ZONING CHANGE REVIEW SHEET

CASE: C814-06-0109 (Lakeshore PUD)

ADDRESS: 2201 Lakeshore Blvd

ZONING FROM: MF-3 **TO:** PUD **AREA:** 50.15 acres

EXHIBIT A
LAND USE PLAN

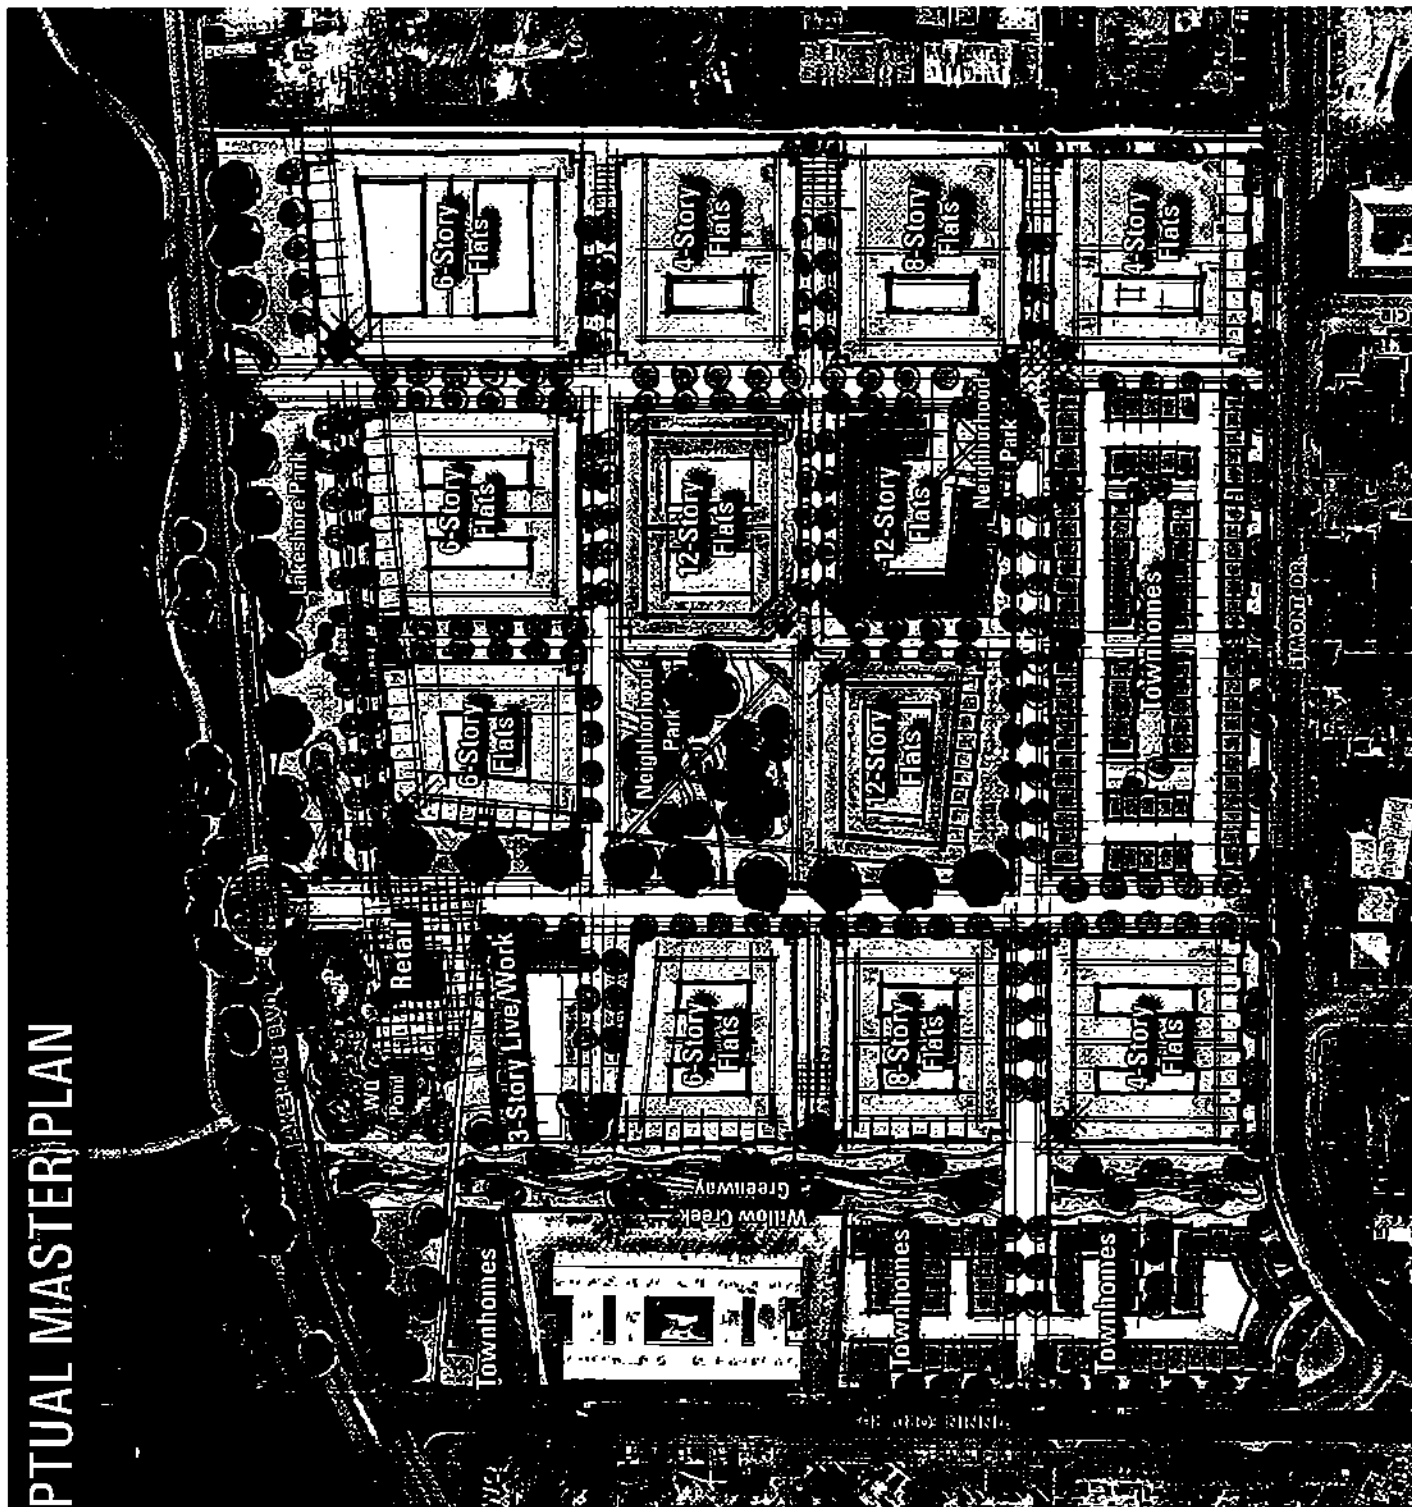
- 1) The PUD should incorporate all of the recommendations of the Traffic Impact Analysis (See Attachment 5)
- 2) Note 9 on the PUD Notes states that private utilities, including water and waste water, be permitted to cross lots. This may not be permitted under the Plumbing Code, and staff recommends that this note be amended to include the caveat "where authorized by the City".

- 3) Note 10 on the PUD Notes should be clarified with the addition "as determined by the City of Austin".
- 4) Note 26 on the PUD Notes states that all structures, 4 stories or taller and consisting of 50,000 square feet of rentable space be required to meet the standards of a 1 star rating under the City's Green Building Program's Multi-family Rating system. Staff recommends that all buildings, regardless of size be required to meet this minimum standard.

- 5) Note 29 on the PUD Notes states that the areas designated as accessible to the general public will be made accessible once 60% of the project dwelling units are occupied. Staff recommends that this be amended to state that the areas designated for public use be accessible once either 60% of the project dwelling units are occupied or no later than 5 years after the PUD is approved by City Council. Additionally, staff recommends this access is guaranteed through dedicated vehicular and pedestrian easements.

- 6) It should be clarified that Site Development Criteria Table 2 on the PUD Notes applies to only townhouses.
- 7) Staff recommends that the Table "Additional Permitted Uses" included in the PUD Notes be amended to prohibit the use "Laundry Services". The Laundry Service use includes large scale commercial laundry cleaning facilities, and does include drop off laundry/dry cleaning uses nor laundry mats.

- 8) Staff recommends that the Table "Additional Permitted Uses" included in the PUD Notes be amended to limit the combined total square footage of Cocktail Lounge or Liquor Sales to no more than 9,000 square feet of space, divided

- EV 3 Please provide off-site drainage acreage for the tributary. If this tributary is classified, please show and label the CWQZ.

Update 1: Pending update information on the CWQZ boundaries per Bury & Partners. Please note that LDC 25-8-92 (B) (1) (2) establishes a CWQZ along Town Lake. Both CWQZ's should be clearly shown and labeled in all future graphic documentation. Depending on the location of the CWQZ on Town Lake and the proposed "100' Waterfront Reserve", the reserve may not hold great value in terms of meeting the "environmentally-superior" criteria. In response to note number 29 and 33, landscaping, sidewalks, and general disturbance is not allowed in a CWQZ. See LDC 25-8-261 for clarification.

EV 7 Please clearly show and label all 100-year floodplain, waterway centerlines, and CWQZ.

WW 1. Change Exhibit A Land Use Plan Notes 1 and 2 to the following:

Response from applicant: See attached letter 11/02/06. As discussed in our meeting with Teresa Alvelo on October 26, 2006, the placement of trails without compacting base, removal of dead trees, removal of invasive tree species, removal of debris and planting of native trees is allowed within the Critical Water Quality Zone (CWQZ) and is consistent with Section 25-8-261 of the Land Development Code (LDC). Additionally the revised PUD plan shows the CWQZ.

Response from applicant: See attached letter 11/02/06. The revised PUD plan shows the 100 year floodplain and CWQZ

Response from applicant: The notes have been changed per your comment.
